RE: Vulture Mine
Draft Groundwater Quality Protection Permit No. G-0090-07

GROUNDWATER QUALITY PROTECTION
PERMIT NO. G-0090-07

DRAFT FOR REVIEW AND DISCUSSION

FIGURE 1
PLAN VIEW OF HEAP LEACH FACILITY
 APPROX. SCALE: 1"=100'

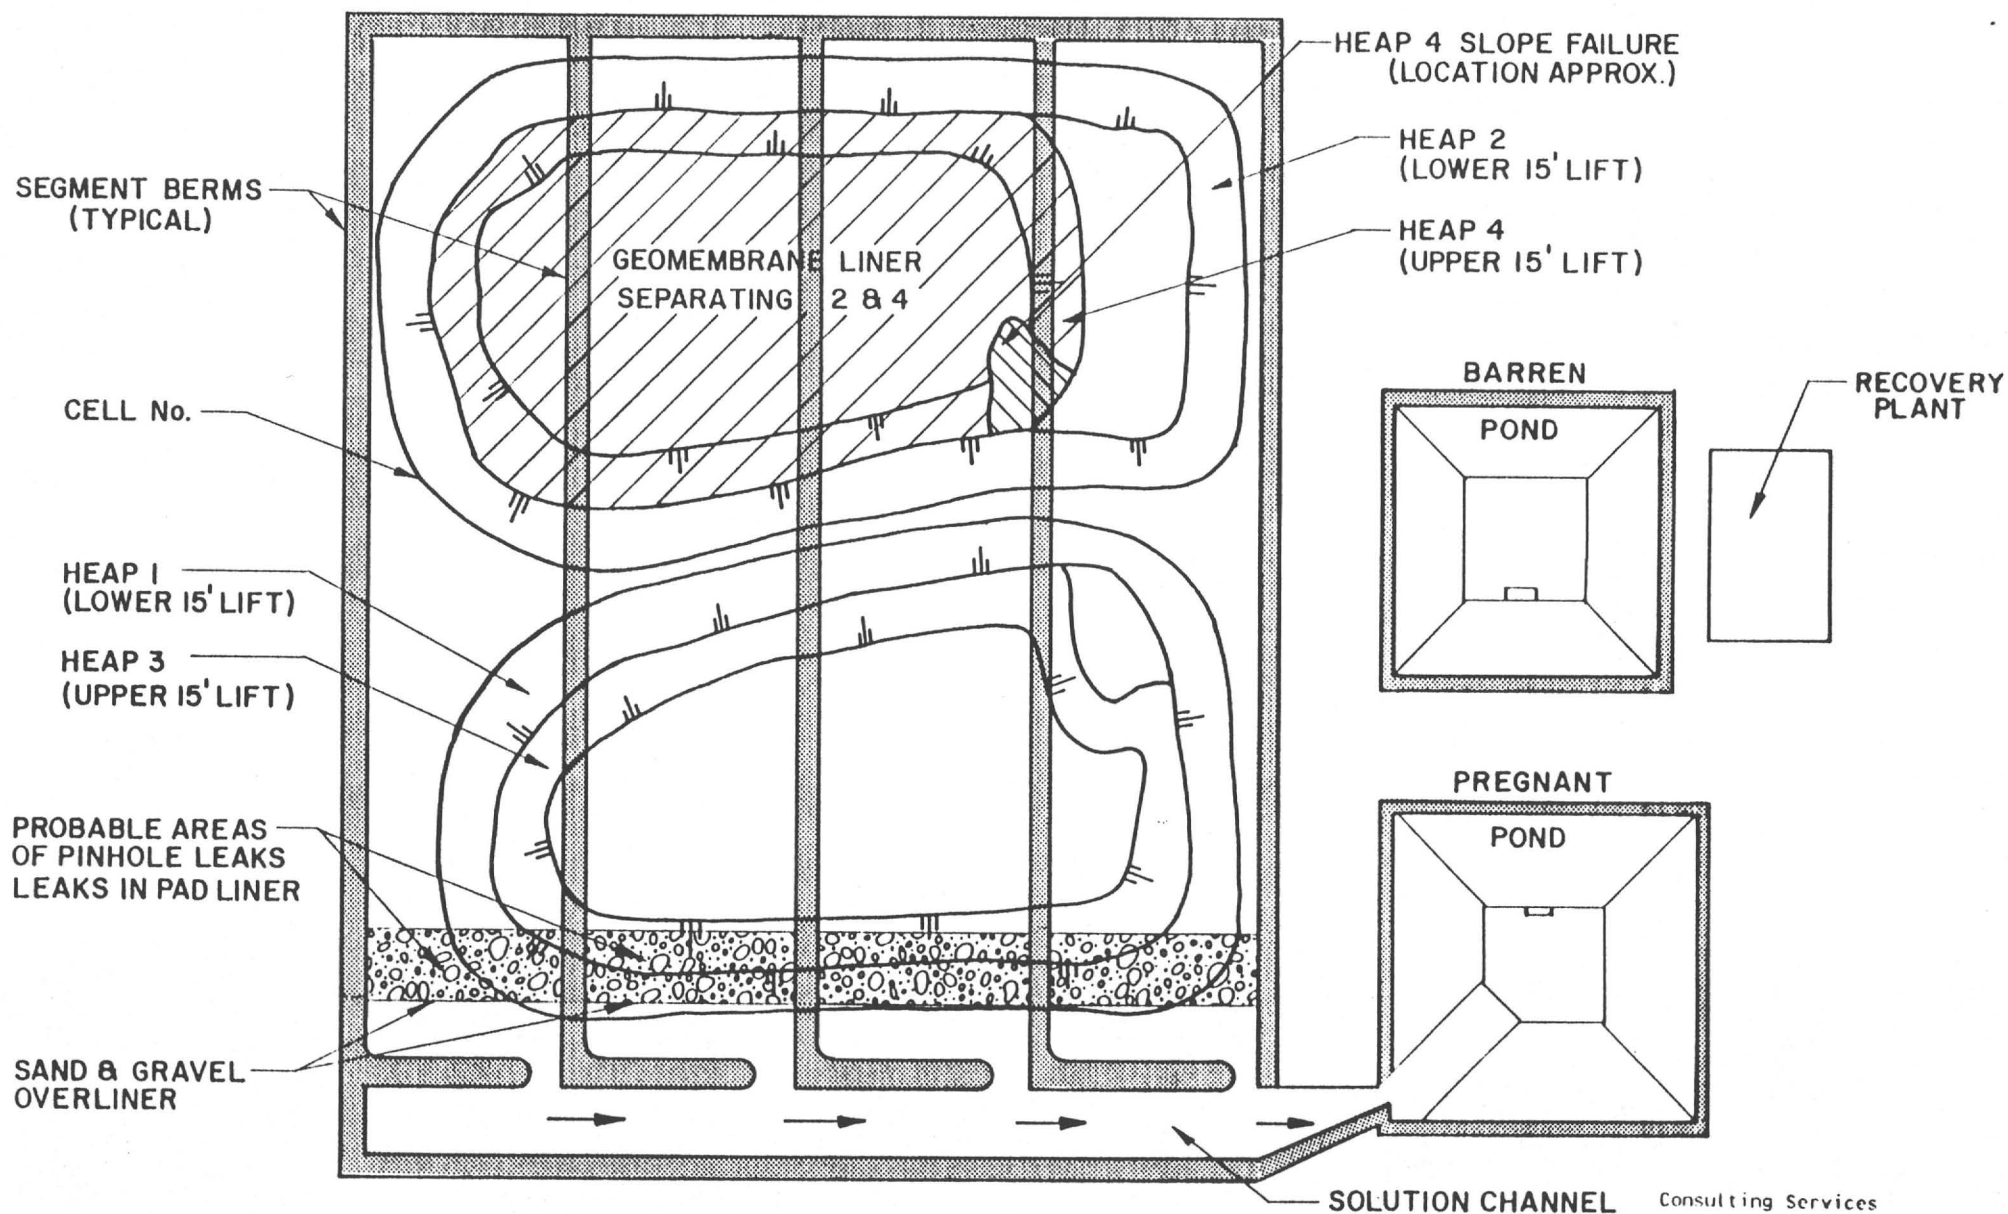
Leach solution was originally detected in the cell no. 2 leak detection system riser pipe, located at the southeast corner of the pad cell, on August 7, 1989. The attached Figure 1 presents a plan view of the heap leach facility. The leakage rate was initially estimated at about 0.0013 gallons per minute (gpm), and tests on the fluid performed by Budge personnel indicated a pH of 11.1 and a free cyanide concentration of 250 milligrams per liter (mg/l). In accordance with the requirements of Parts II.A.4, II.B.1.b and II.C.1 of Groundwater Quality Protection Permit No. G-0090-07, this initial leak was reported to the DEQ and the Maricopa County Health Department in our letter of August 10, 1989.

Application of leach solution to the south half of cell nos. 1, 2 and 3 (the heap no. 3 area as presented in Figure 1) was discontinued on September 22, 1989. As can be seen in Table 1, as of October 17, 1989, the leakage flow rate had generally decreased from an upper limit of 0.04 gpm to 0.01 gpm, with minor fluctuations in mid-September, 1989. The free cyanide concentration and pH also decreased from highs of 300 mg/l and 11.7 to 50 mg/l and 8.3, respectively.

The existing leach pile height is about 30 feet, comprised of two 15-foot lifts. The individual 15-foot lifts are numbered as shown in Figure 1. The separation between the north and south heaps as shown in Figure 1 was purposely maintained during stacking of the tailings on the leach pad in order to provide some independence between the north and south halves. Four to six corrugated, perforated drainage pipes per cell are located on the pad liner, immediately beneath heaps 1 and 2. These pipes function to keep the solution head in the heaps at a low level by augmenting the drainage of the heaped tailings.

As depicted in Figure 1, a 20-mil thickness HDPE geomembrane liner panel was placed on the crest of heap no. 2, prior to stacking the heap no. 4 lift. This liner panel was placed by Budge personnel in an attempt to confine the leach solution to the upper (heap no. 4) lift, preventing releaching of the spent heap no. 2 tailings. It is our understanding that during leaching of heap no. 4, a leach solution line located at the southeast corner of the crest of heap no. 4 failed, resulting in inundation of that portion of the heap. Aided by the low basal frictional resistance caused by the underlying geomembrane liner, the saturated tailings slope then failed.

Based on our understanding of the operations and conditions at the heap leach facility, it is anticipated that the leaks through the 30-mil thickness high density polyethylene (HDPE) geomembrane pad liner are most likely in the form of pinholes beneath the sand and gravel overliner material at the toe of cell nos. 1 and 2 (Figure 1). Other than physically removing the overliner material and vacuum testing the suspected damaged liner area, there are no reliable methods for identifying defects in an in-place geomembrane liner. It is our opinion that, given the cessation of leach solution application to cell nos. 1 and 2 and the anticipated remaining 6-month project life, it would be of no productive use to attempt to remove the overliner material and repair the suspected defects. It is felt that any repair attempts would most likely result in more damage to the liner from the hand labor necessary to expose the liner than presently exists.

FIGURE 1
PLAN VIEW OF HEAP LEACH FACILITY
 APPROX. SCALE: 1"=100'

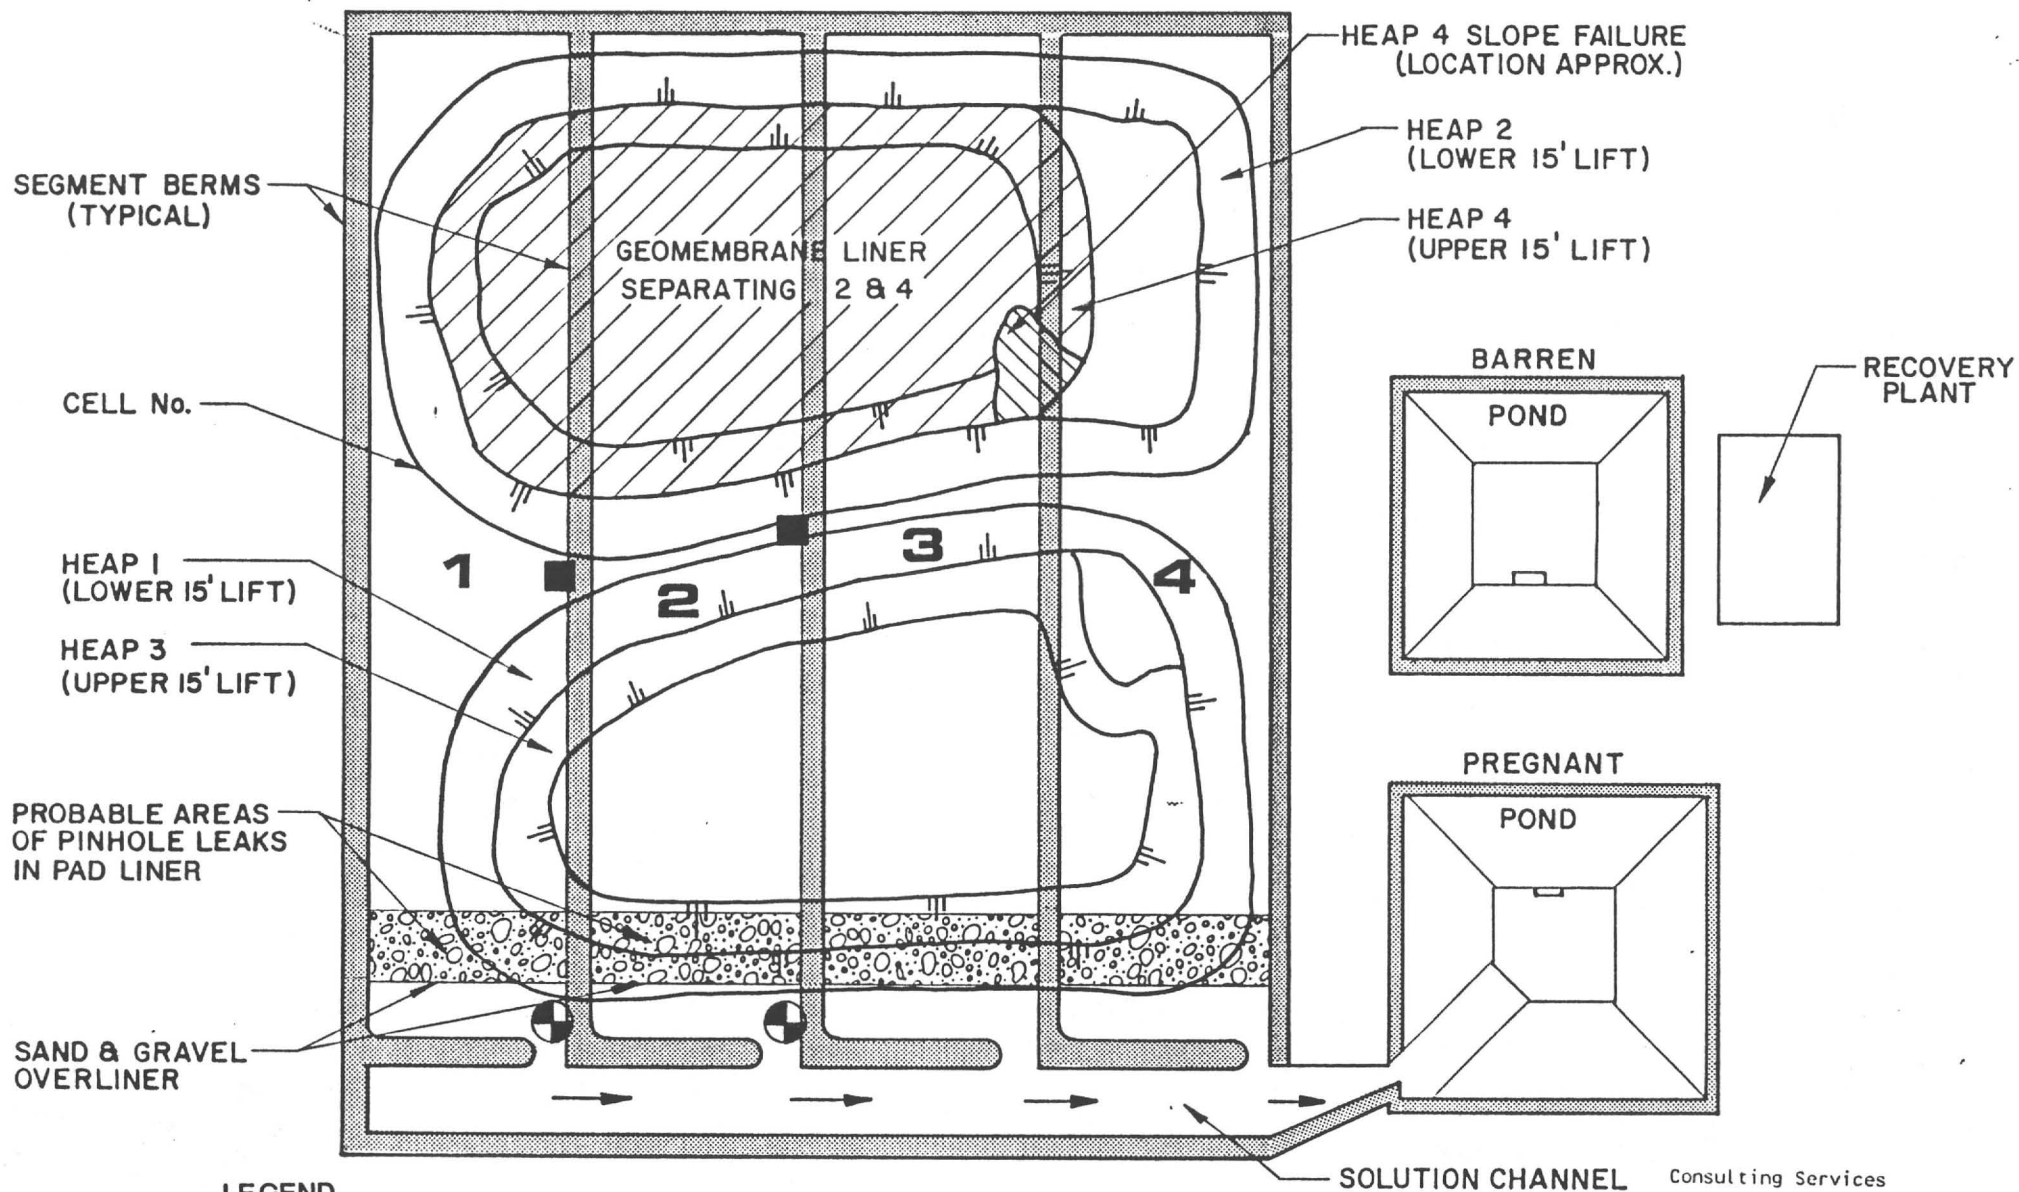
- The existing leak detection system trench adjacent to the cells 1 and 2 segment berms will be exposed by opening up the primary pad liner at approximately the north-south midpoint of each cell, at the two locations shown in Figure 1. Any fluid encountered in the trench will be sampled and tested for cyanide. Hydraulic communication of the leak detection system with the south half of each cell will be prevented via the installation of a flap of liner material sealed to the trench bottom liner and extending to the top (primary) liner. A riser pipe permitting future sampling will be installed at each location and the primary liner resealed and booted to the new riser pipe.

FIGURE 1
PLAN VIEW OF HEAP LEACH FACILITY

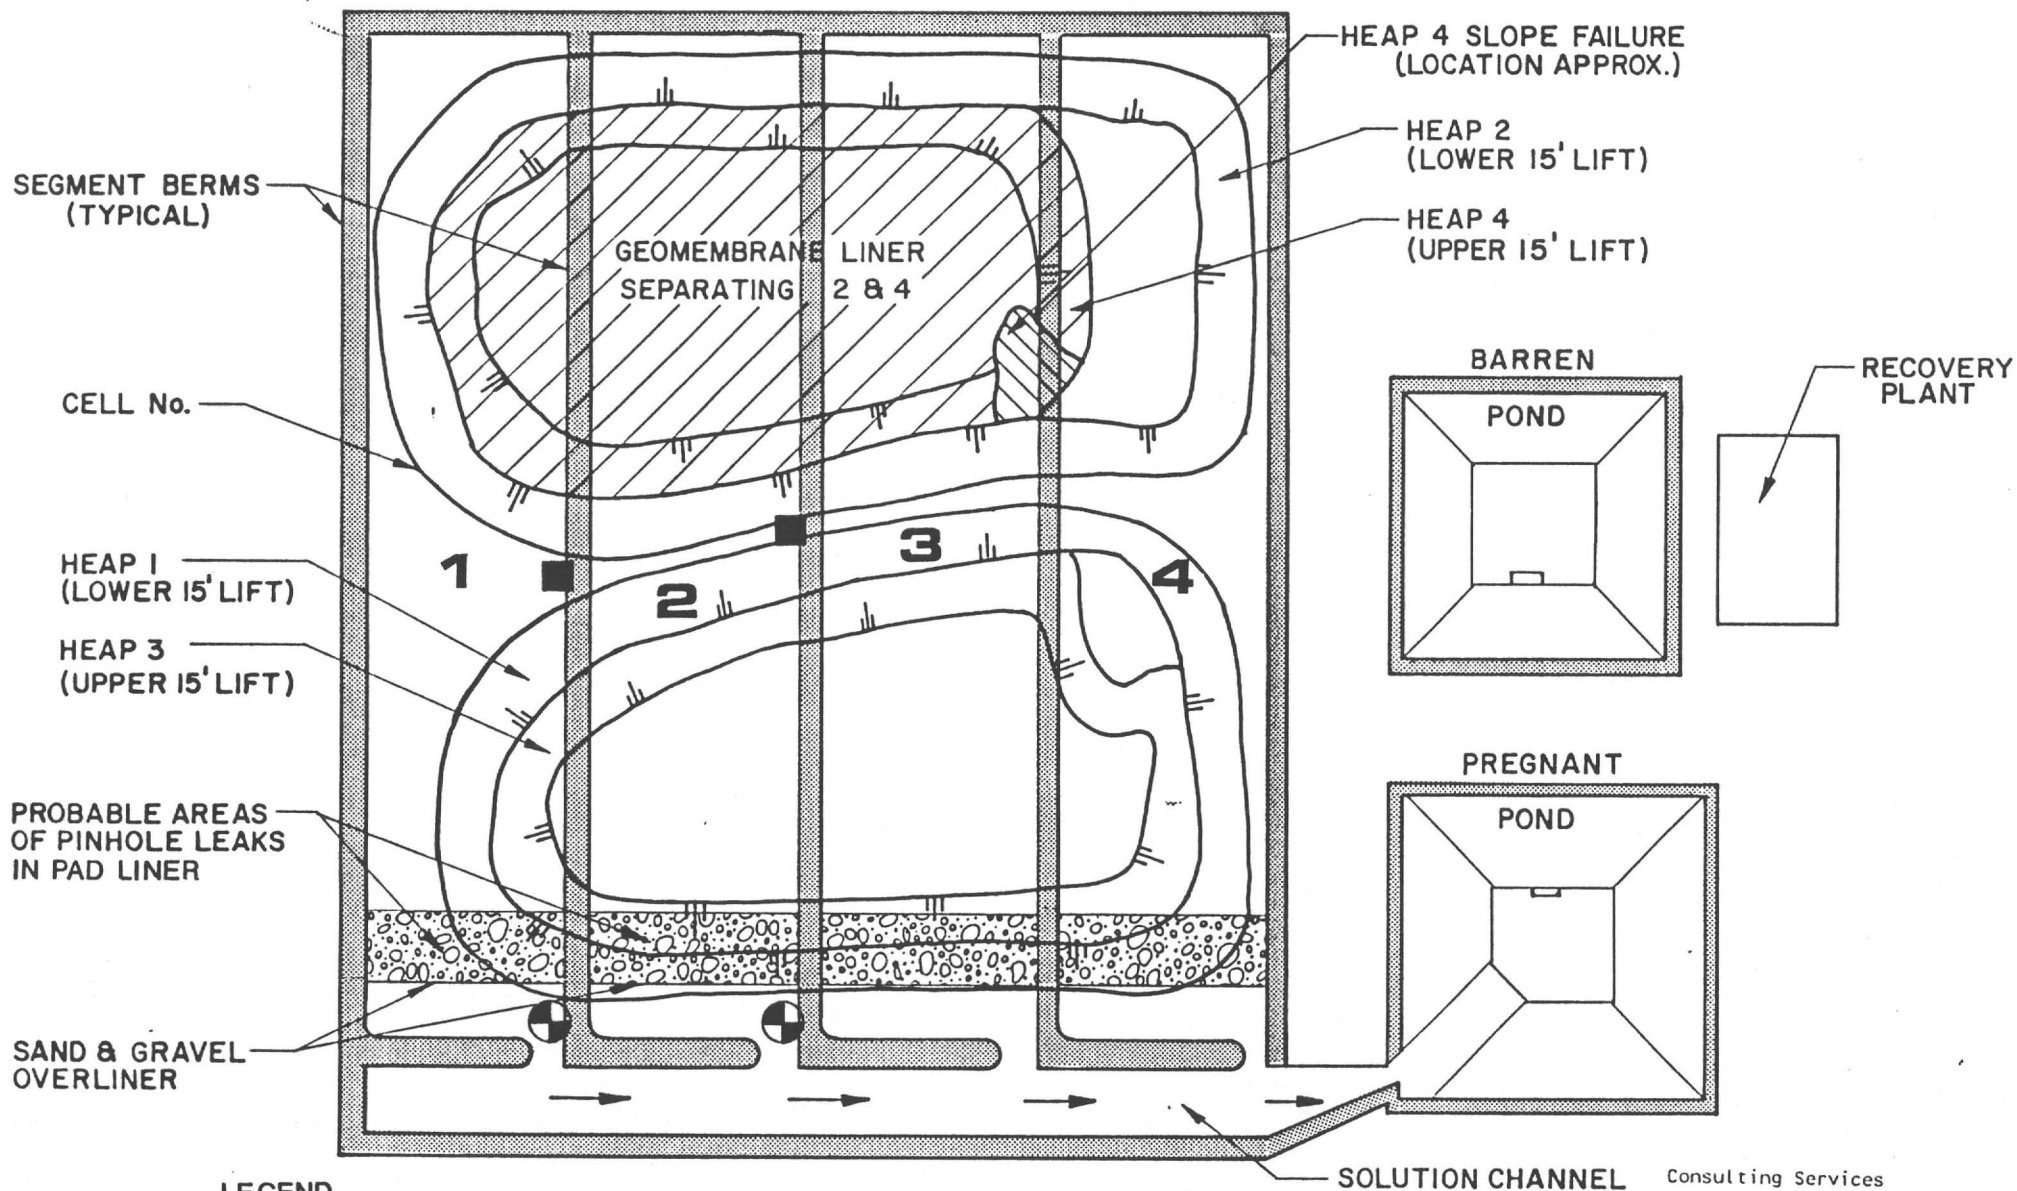
- The existing leak detection system trench adjacent to the cells 1 and 2 segment berms will be exposed by opening up the primary pad liner at approximately the north-south midpoint of each cell, at the two locations shown in Figure 1. Any fluid encountered in the trench will be sampled and tested for cyanide. Hydraulic communication of the leak detection system with the south half of each cell will be prevented via the installation of a flap of liner material sealed to the trench bottom liner and extending to the top (primary) liner. A riser pipe permitting future sampling will be installed at each location and the primary liner resealed and booted to the new riser pipe.

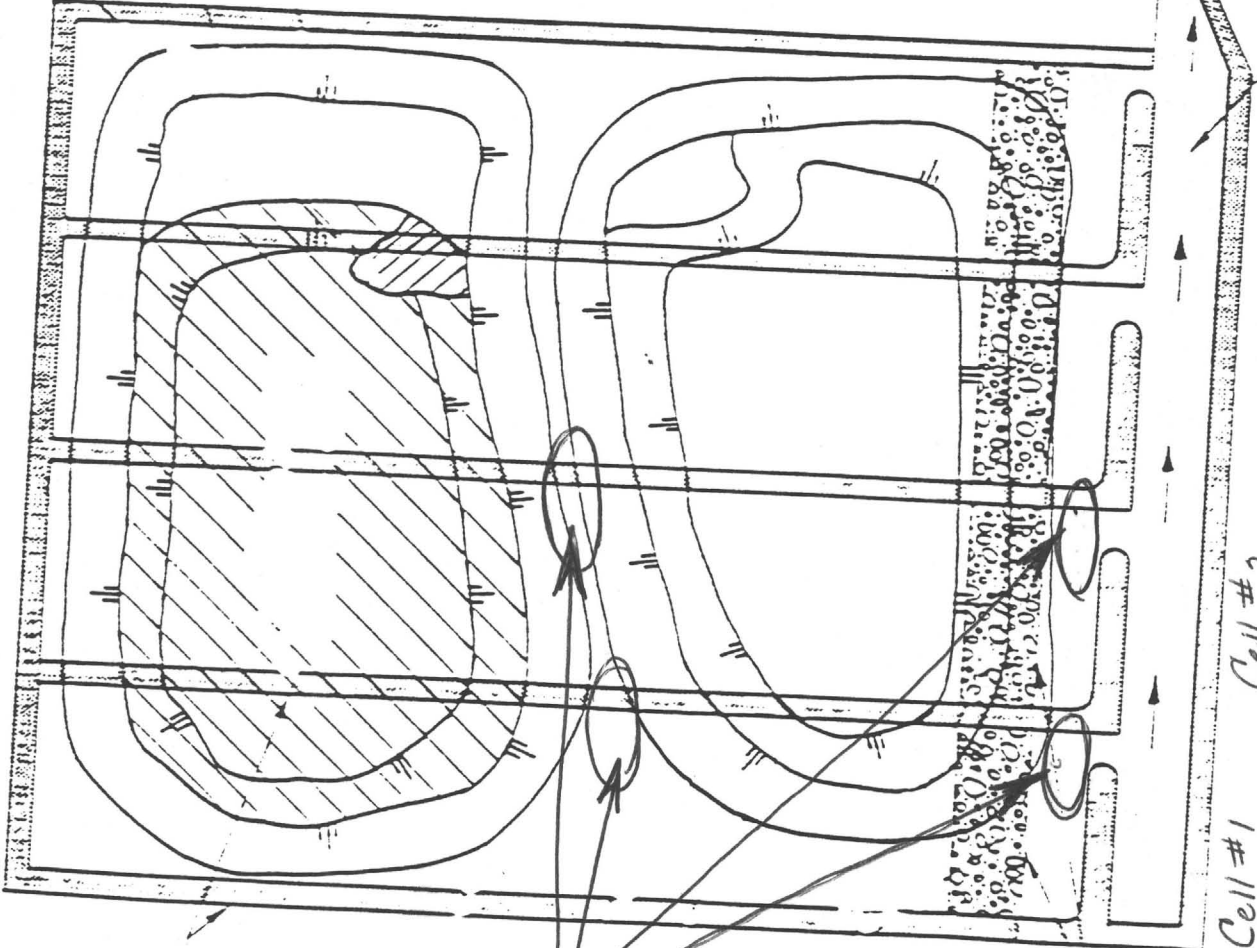
Ron called at 2 p.m. and asked me to pass along results of the meeting and site visit by DEQ. They did not show up until 11:30 and so visit extended until 2 p.m. They actually stayed beyond that time to sample in the area where they thought we had breached the berm on north^{east}~~west~~ side.

A picture is supposedly worth 1,000 words. Diagram follows showing desired sample locations.
